## NOTICE OF ADOPTED AMENDMENT

SUBJECT: City of Sherwood Plan Amendment  
DLCD File Number 003-12

### **AN ORDINANCE APPROVING AN AMENDMENT TO THE TRANSPORTATION SYSTEM PLAN AND COMPREHENSIVE PLAN REGARDING THE FUNCTIONAL CLASSIFICATION OF CEDAR BROOK WAY**

**DATE:** July 10, 2012  
**TO:** Bob Galati, City of Sherwood  
**FROM:** Carl Springer, PE; John Bosket, PE; Garth Appanaitis  
**SUBJECT:** Sherwood Transportation System Plan Clarifications for Elwert Road Connection P#12051-000

• Figure 8-8: Local Street Connectivity

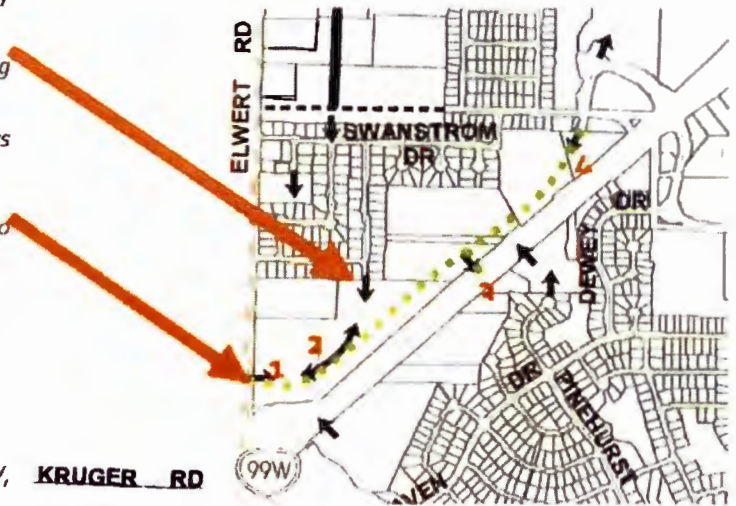
- *Retain arrow showing local street connection to Bushong Terrace*
- *Replace (overlay) four arrows on map indicating the local street connections with the proposed collector. Arrows to replace include:*
  - 1) *connection to Elwert Road,*
  - 2) *swooping connection from Elwert Road to Bushong Terrace*
  - 3) *connection to Hwy 99W, and*
  - 4) *Connection to Cedar Brook Way.*

Figure 8-7: Streets Where ROW is Planned for More Than Two Lanes

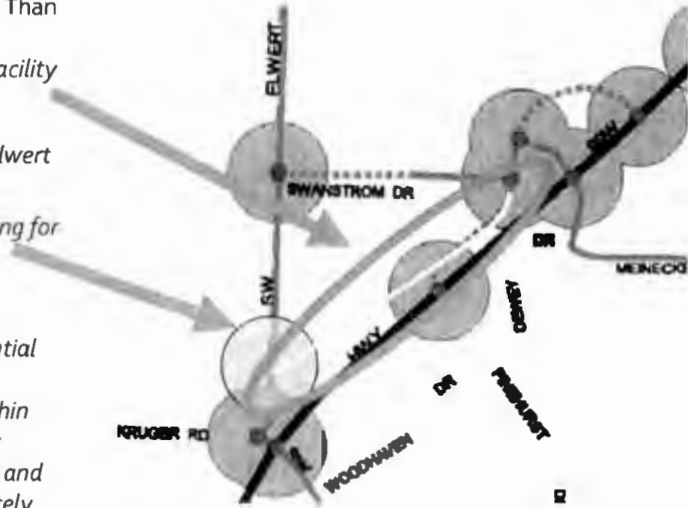
- *Modify the designation of the new facility as a 2-lane facility.*
- *Indicate the new intersection with Elwert Road would be an arterial-collector intersection and may include widening for turn pockets within 500 feet of the intersection.*
- *Add the following note for the potential Highway 99W access: A potential Hwy99W access point is located within the limits of the access zone (990' or greater from both Sunset Boulevard and Meinecke Road provides approximately 2000' of flexibility for access placement) as delineated in the prior study. The actual location will be based on transportation design standards and will take place when development occurs.*

Figure 8-7: Streets Where ROW is Planned for More Than Two Lanes

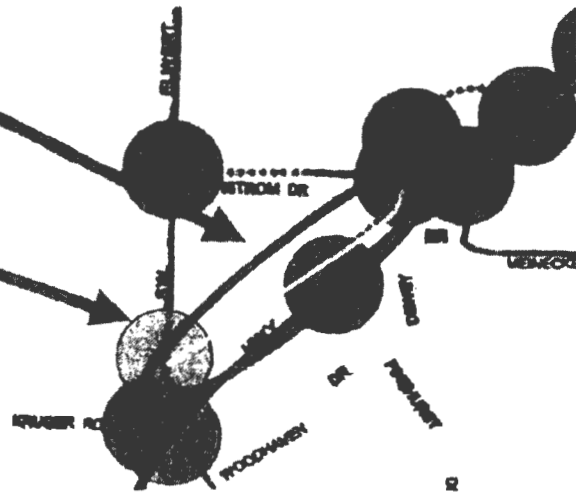
- Modify the designation of the new facility as a 2-lane facility.
- Indicate the new intersection with Elwert Road would be an arterial-collector intersection and may include widening for turn pockets within 500 feet of the intersection.
- Add the following note for the potential Highway 99W access: A potential Hwy99W access point is located within the limits of the access zone (990' or greater from both Sunset Boulevard and Meinecke Road provides approximately 2000' of flexibility for access placement) as delineated in the prior study. The actual location will be based on transportation design standards and will take place when development occurs.

Figure 8-8: Local Street Connectivity

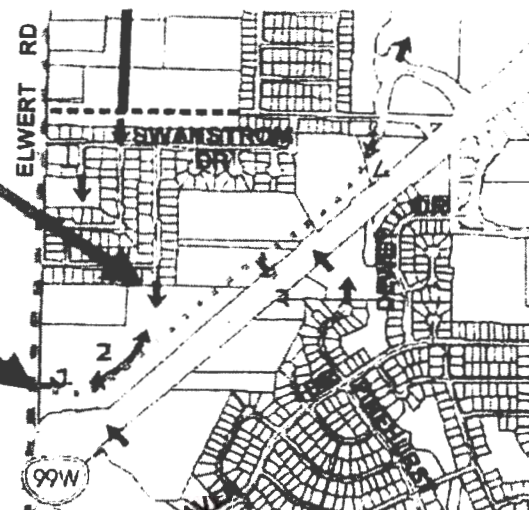
- Retain arrow showing local street connection to Bushong Terrace
- Replace (overlay) four arrows on map indicating the local street connections with the proposed collector. Arrows to replace include:
  - 1) connection to Elwert Road,
  - 2) swooping connection from Elwert Road to Bushong Terrace
  - 3) connection to Hwy 99W, and
  - 4) Connection to Cedar Brook Way.

*This a  
 diagrammatically  
 slopy  
 illustration*

Figure 1: Local Street Connectivity  
(Enlargement of Sherwood TSP Figure 8-8)

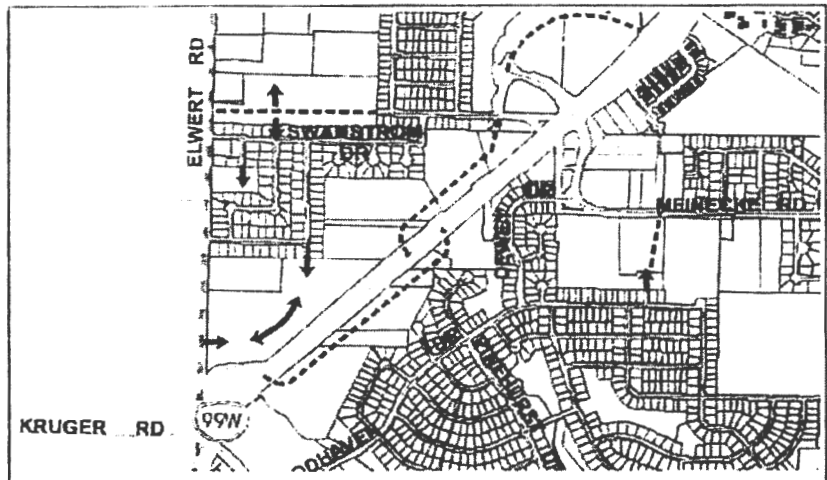
*false statement*

Figure 2: Study Area

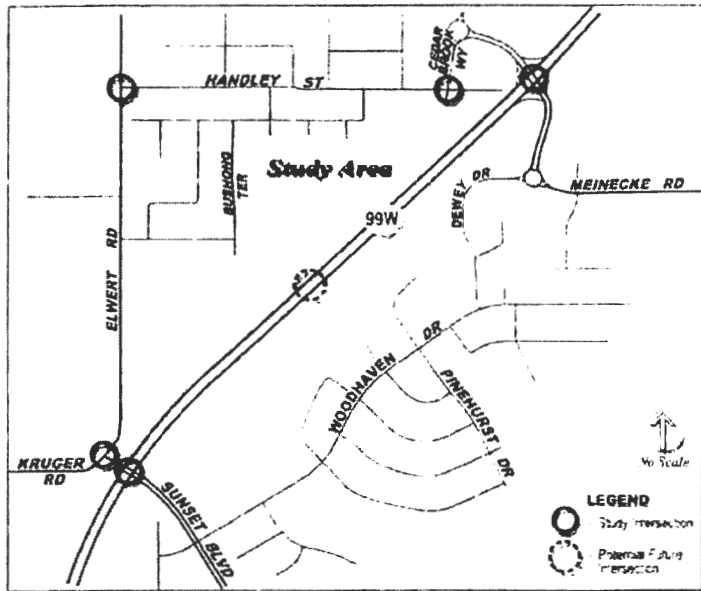
*only one  
 scale is  
 attached*
